WELL API NO. 30-015-21416	
5. Indicate Type of Lease STATE FEE X	
6. State Oil & Gas Lease No.	
7. Lease Name or Unit Agreement Name TRACY B COM	
8. Well Number 001	
9. OGRID Number 330859	
10. Pool name or Wildcat CARLSBAD; MORROW, SOUTH (GAS)	
4. Well Location Unit Letter: I : 2,045 feet from the SOUTH line and 479 feet from the EAST line Section 18 Township 22S Range 27E NMMPM County EDDY	
11. Elevation (Show whether DR, RKB, RT, GR, etc.) 3,108' - GR

The McDaniel Company P&A Procedure

ALPHA ENERGY PARTNERS LLC
 TRACY B COM #001
 API: 30-015-21416
 EDDY COUNTY, NM

Action 543240

Proposed WBD

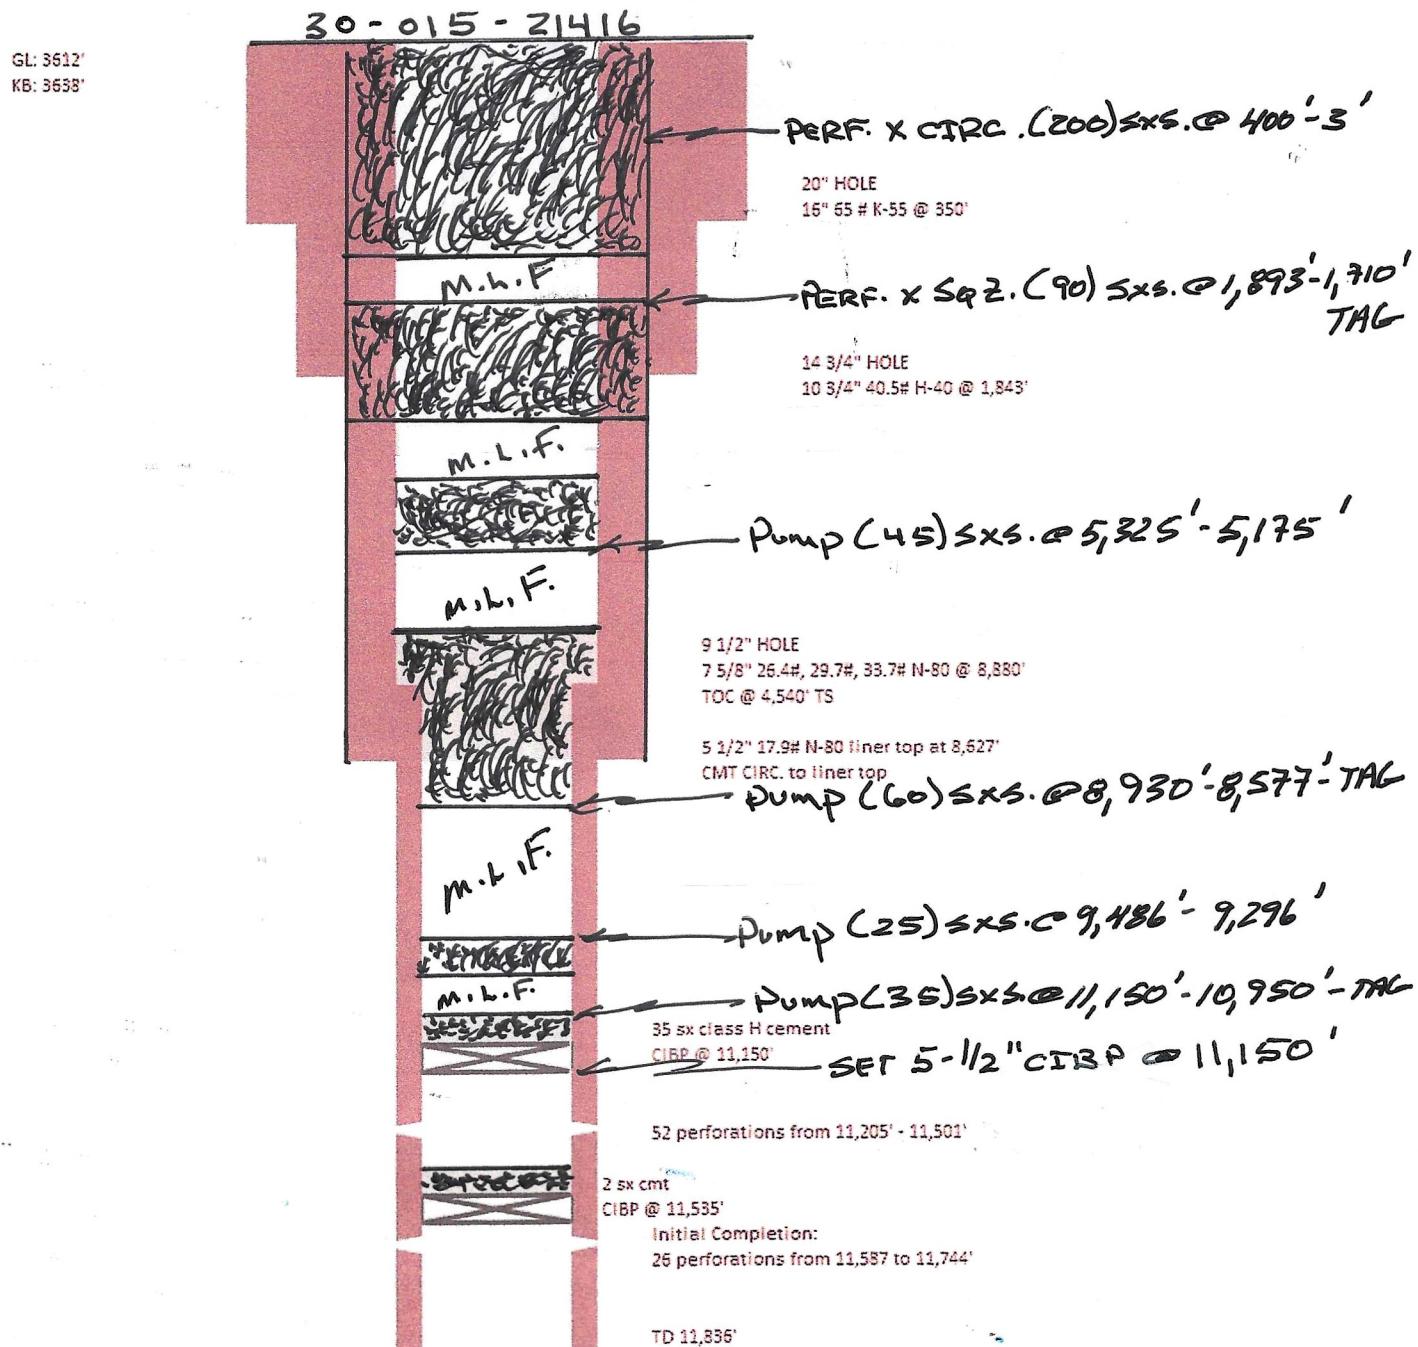
13. Spot 35 sx cmt 10530' - 9830' - T Atoka, Penn
14. RIH W/ TBG TO 9,486'.
15. MIX & SPOT A 25 SX CMT PLUG FROM 9,486'-9,296'.
16. POOH W/ TUBING TO 8,930'

20. Spot 25 sx cmt 3500' - 3200' - required spacer
21. POOH W/ TUBING TO 1,850'
22. RU WLU & MAKE UP PERF GUN. RIH & SHOOT SQZ HOLES @ 1,893'. POOH & RD WLU.

26. ESTABLISH CIRC UP BACKSIDE THROUGH PERFS @ SURF. MIX & CIRC 200 SX CMT UP FROM 400'- SURF. WOC & Bubble test
27. POOH WITH TBG & ND BOPS.
28. RIG DOWN RIG AND RELATED EQUIPMENT.

29. DIG OUT CELLAR & TOP OFF WELL AS NEEDED.
30. CUT AND CAP WELL with AGL Marker - DIG OUT & CUT OFF ANCHORS.
31. BACK FILL CELLAR.
32. MOVE OFF LOCATION, JOB COMPLETE.
